**TOWN OF WATERTOWN
PLANNING AND ZONING COMMISSION
REGULAR MEETING AGENDA
Wednesday, May 6, 2026, 6:30 p.m.
Watertown Town Hall, Town Council Chambers
61 Echo Lake Road**

Date: March 19, 2026

Subject: Palm Coast Capital LLC
Proposed Tractor Supply Company Facility
0 Hillside Avenue
Oakville, CT

I have reviewed the latest Site Plans (23 sheets total) dated 05/23/25 as revised to 3/10/26, by Solli Engineering for the above referenced project. I have the following comments for your consideration:

UG-1 STORMWATER SYSTEM RISER DETAIL

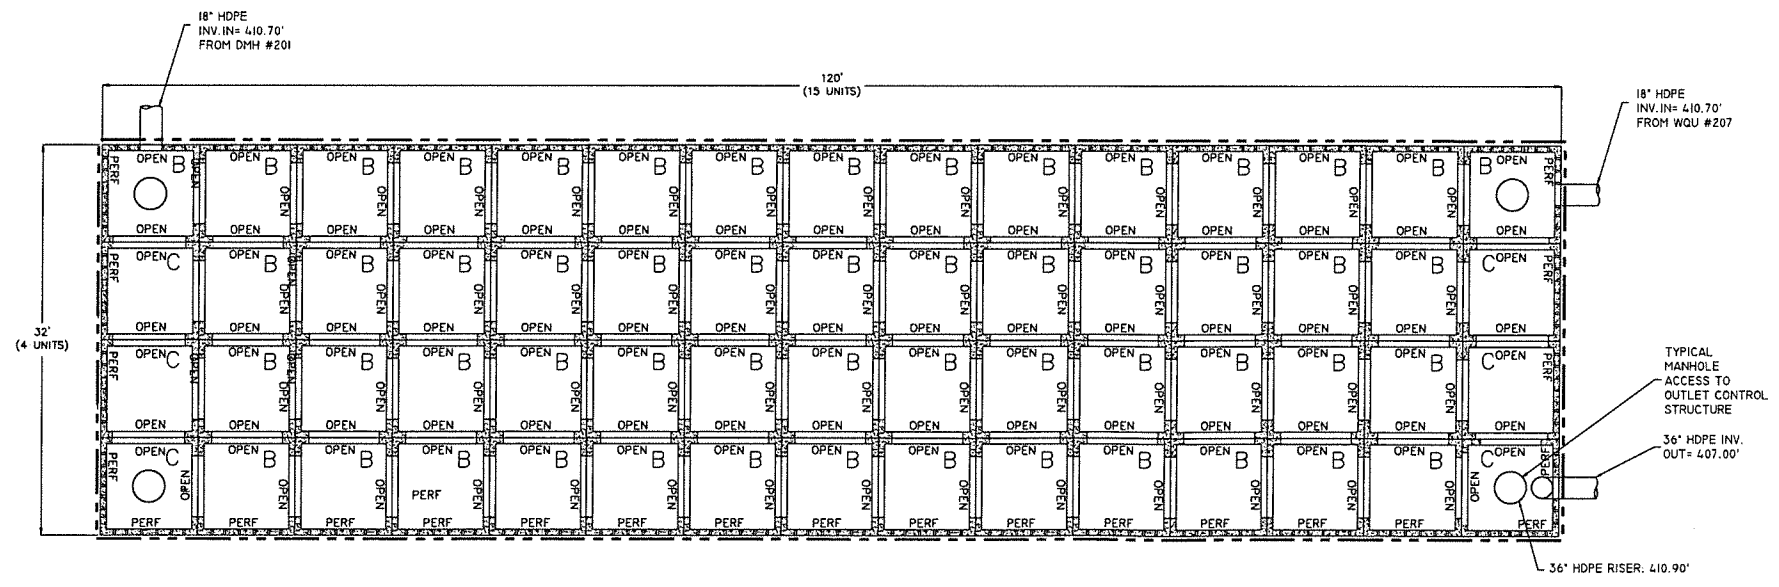
- 1) The revised Plans show an underground infiltration system in lieu of the previously approved water quality pond. Some issues with the new system are

- d) The system grading should provide for a level five foot shelf on the downgradient side of the infiltrators to reduce the possibility of stormwater bleed out leading to eroding of the downslope.

- e) The Stormwater System Detail on Sheet 2.22 should show the extent of the stone surrounding the units.
